STAFF REPORT
COMMUNITY DEVELOPMENT DEPARTMENT

SUBJECT: FP-2020-0014
Stapleton No. 2

Final Plat consisting of 63 buildable lots and 8 common lots on 10.6 acres of land in the R-15 zoning district.

B. Final Plat (date: 1/5/2021)

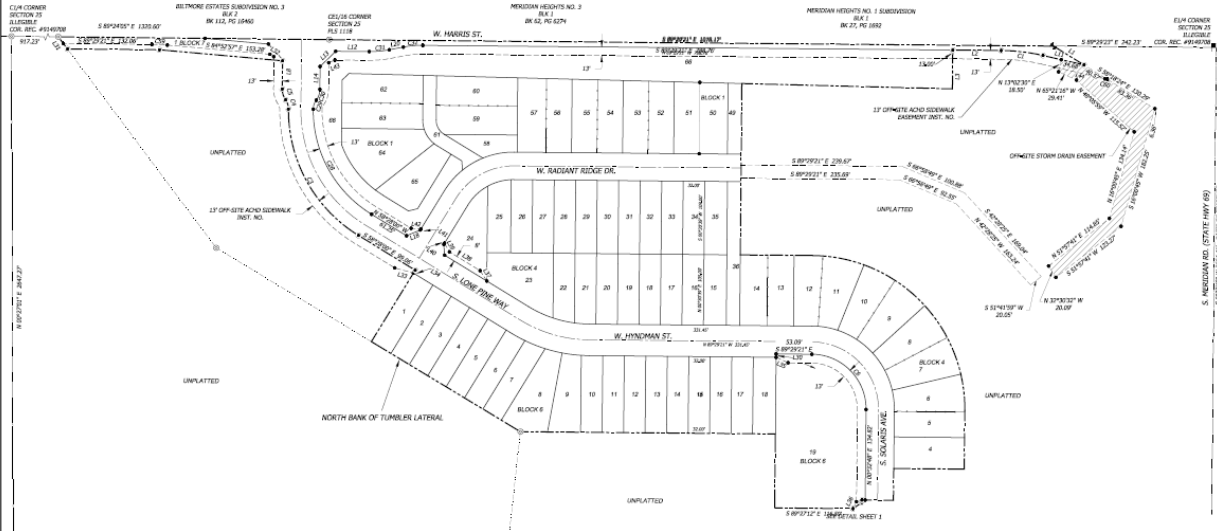
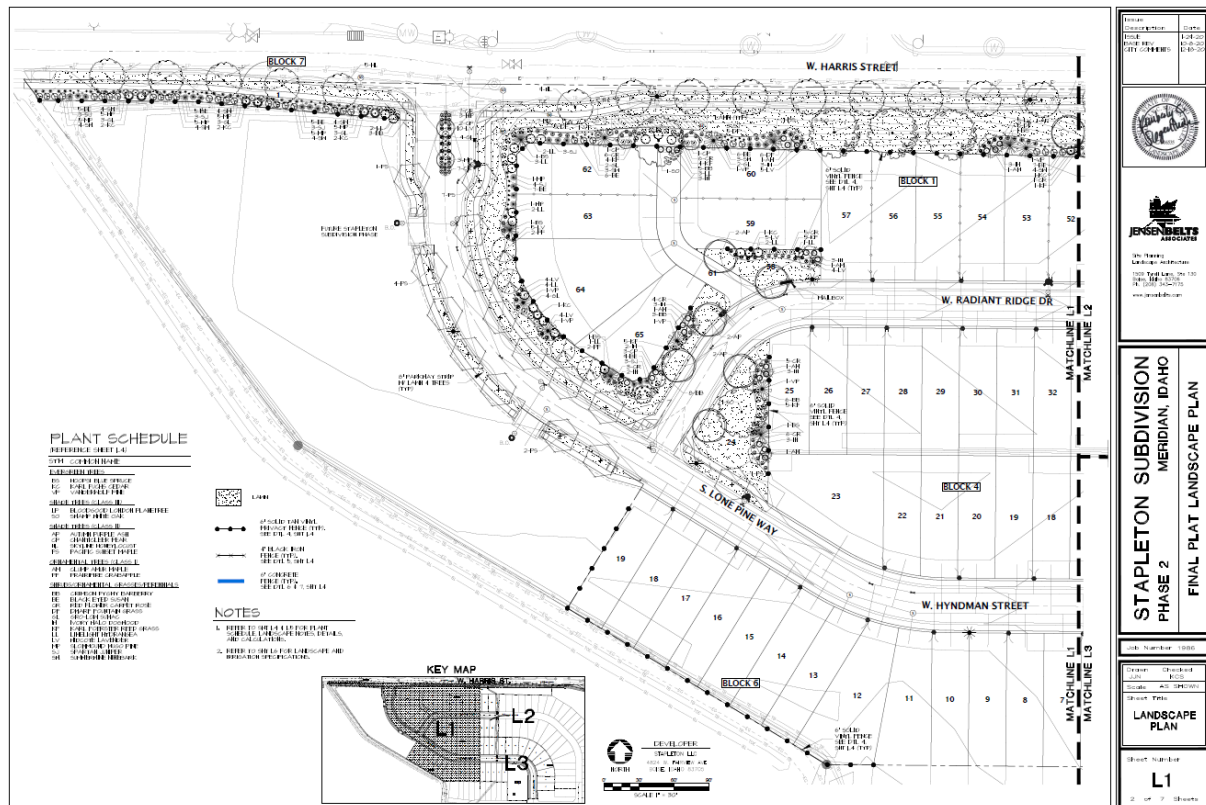
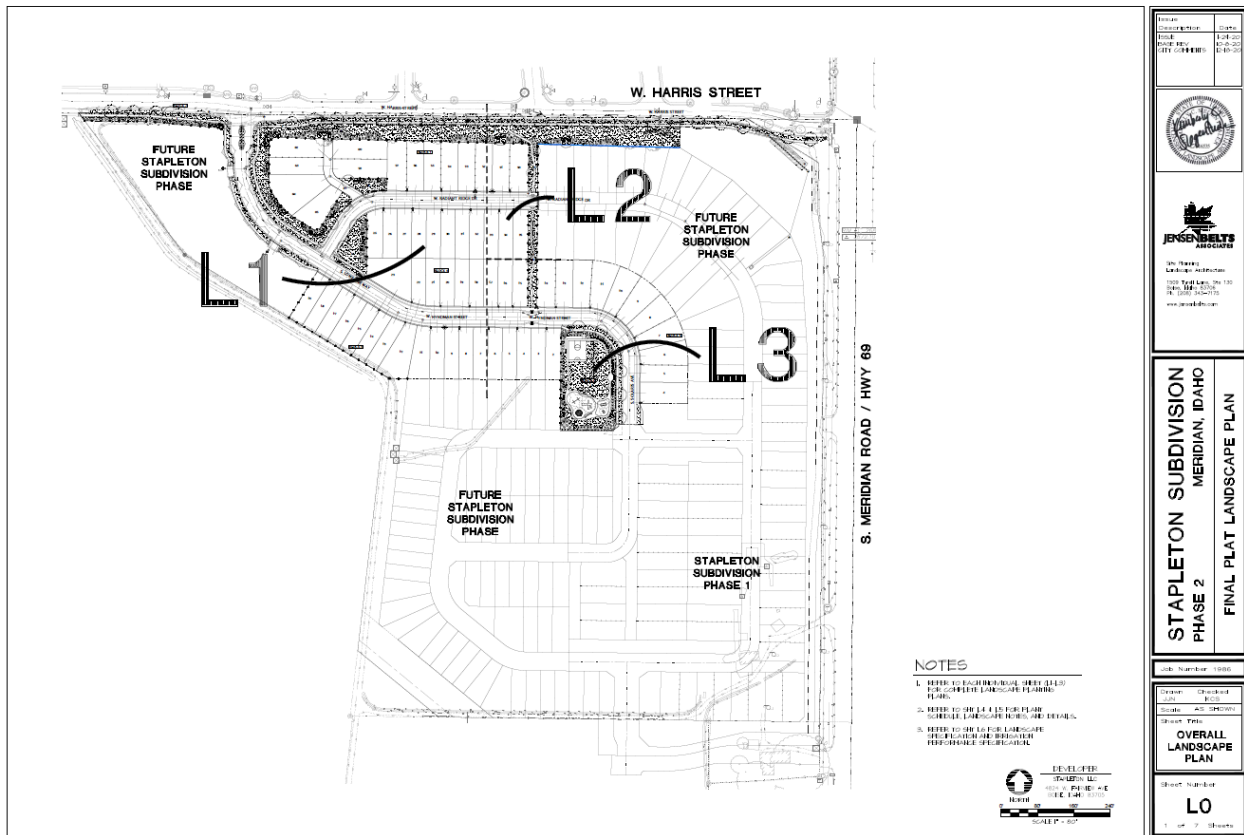
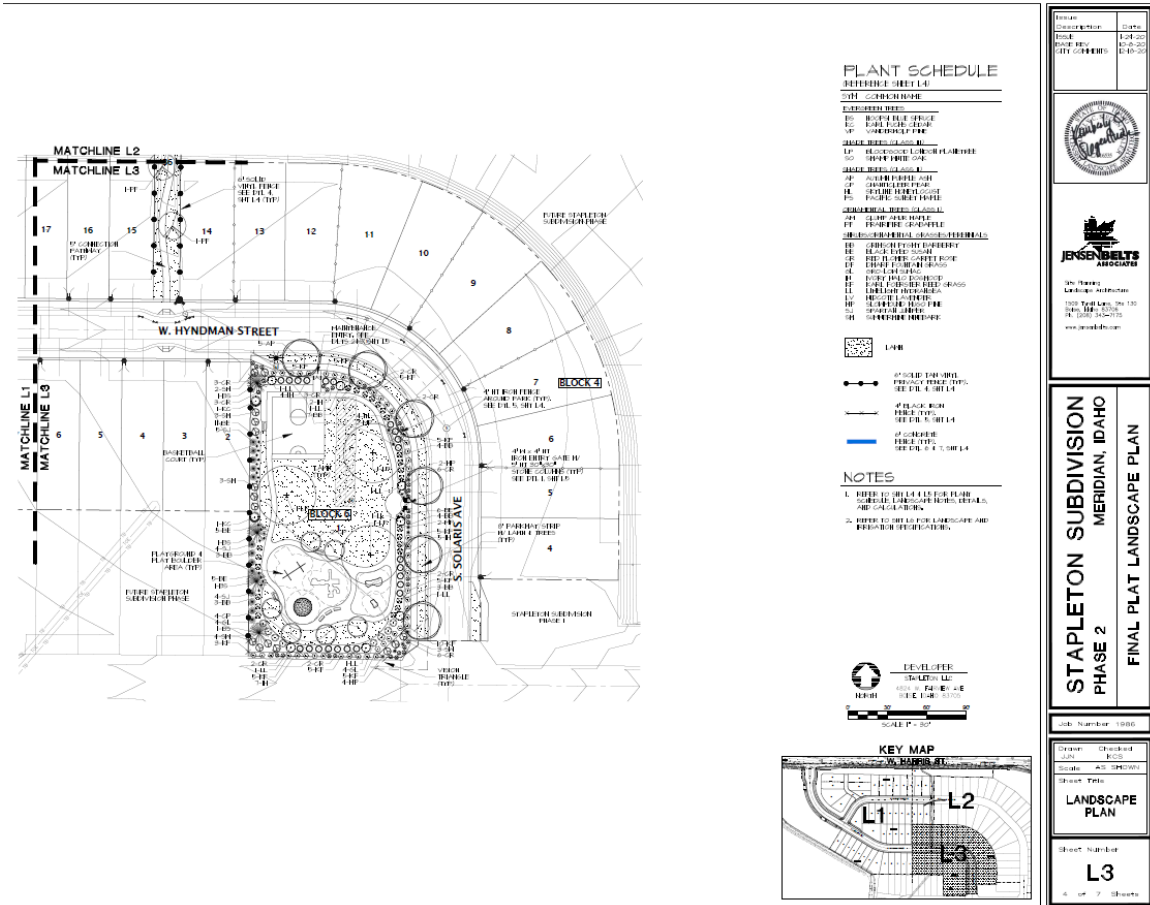
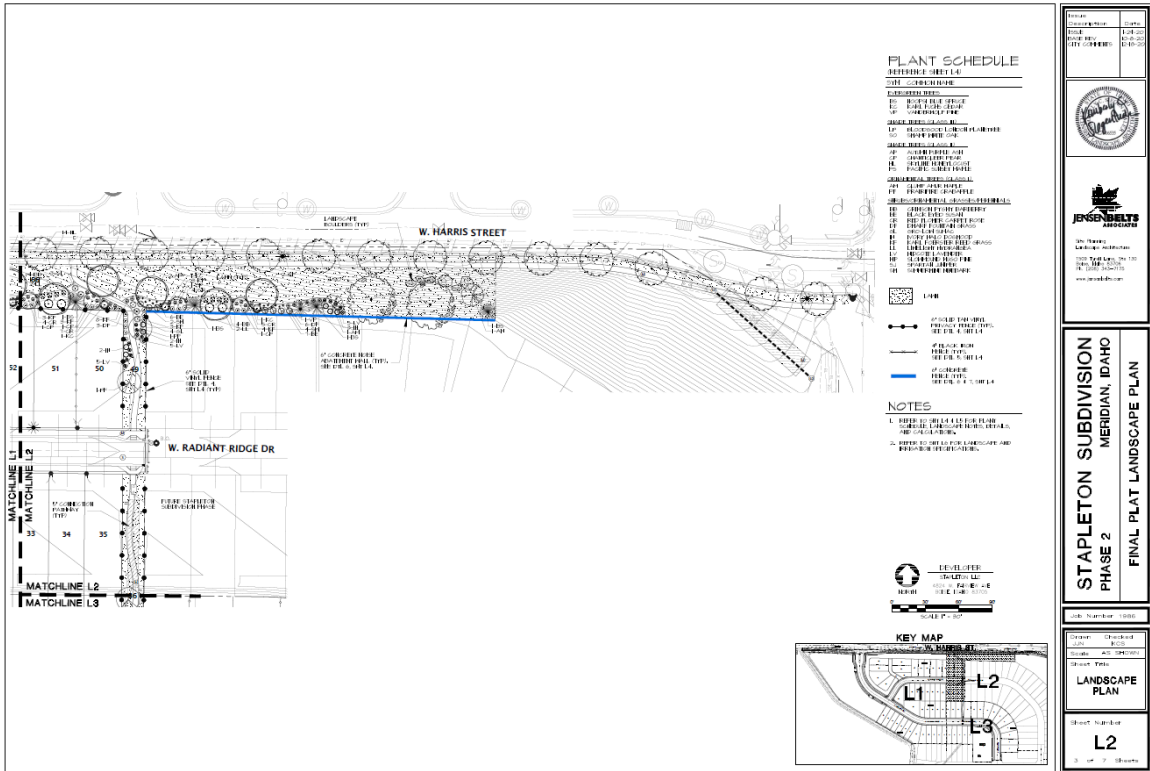
1. Applicant shall comply with all previous conditions of approval associated with this development (H-2018-0129, Development Agreement #2019-110907).
2. **The applicant shall obtain the City Engineer's signature on the subject final plat within two years of the City Engineer's signature on the previous phase final plat; or apply for a time extension, in accord with UDC 11-6B-7.**
3. Prior to submittal for the City Engineer's signature, have the Certificate of Owners and the accompanying acknowledgement signed and notarized.
4. The final plat prepared by Kevin M. Borah, Sawtooth Land Surveying, LLC, dated 1/5/2021, included in Section VII.B shall be revised as follows:

Legend:

- a. Include the recorded instrument number for the ACHD sidewalk easement.
- b. Include the recorded instrument number for the ACHD storm drain easement.

Notes:

- c. Note #5: Delete note; Homeowner's Associations are not governed by the City of Meridian.
- d. Note #6: ". . . Lot 19, Block 6, and Lot 1, Block 7 are reserved as common area. . ."
- e. Note #7: Include recorded instrument number for ACHD license agreement.
- f. Note #13: ". . . Lot 19, Block 6, are servient to and contain the ACHD storm water drainage system. . ."
- g. Note #14: Include recorded instrument number of ACHD sidewalk easement.
- h. Note #15: "The bottom of structural footing shall be set a minimum of 12-inches above the highest established normal ground water elevation."

Face of the plat:

- i. Depict the north/south shared lot line between Lots 50 and 51, Block 1 (Sheet 1).
 - j. Include the Surveyor's Narrative (Sheet 3).
 - k. Include the recorded instrument number for the ACHD sidewalk easement (Sheet 4).

C. Landscape Plan (dated: 12/18/20)

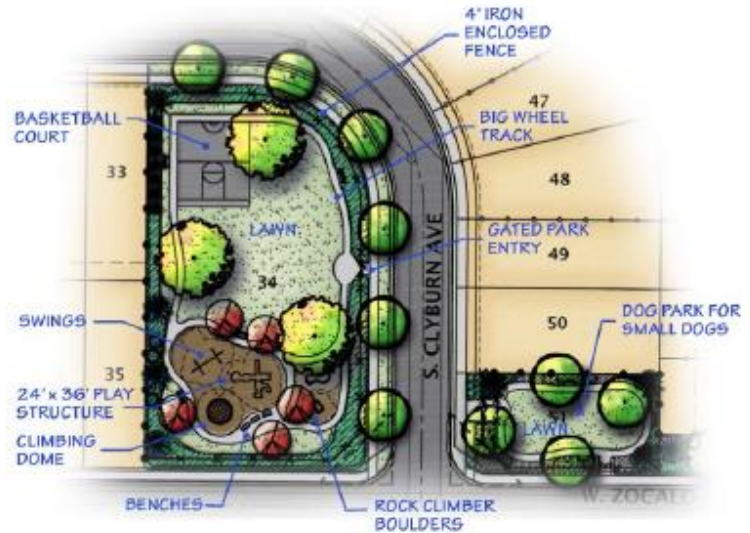
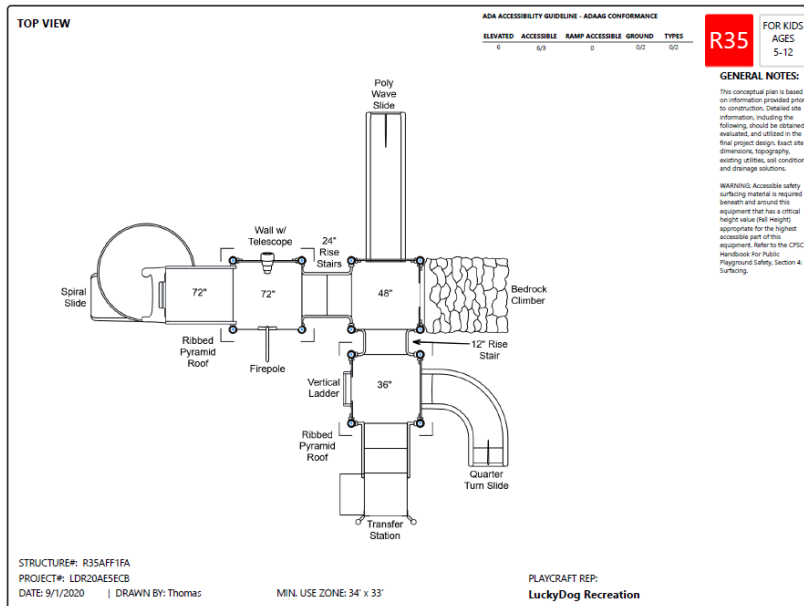
5. The landscape plan prepared by Jensen Belts Associates, dated 12/18/20, shall be revised as follows:
 - a. Re-number the lots consistent with the final plat.

- b. Include the total linear feet of parkways and the required number of trees in the Landscape Calculations table per the standards listed in UDC 11-3B-7C.3.
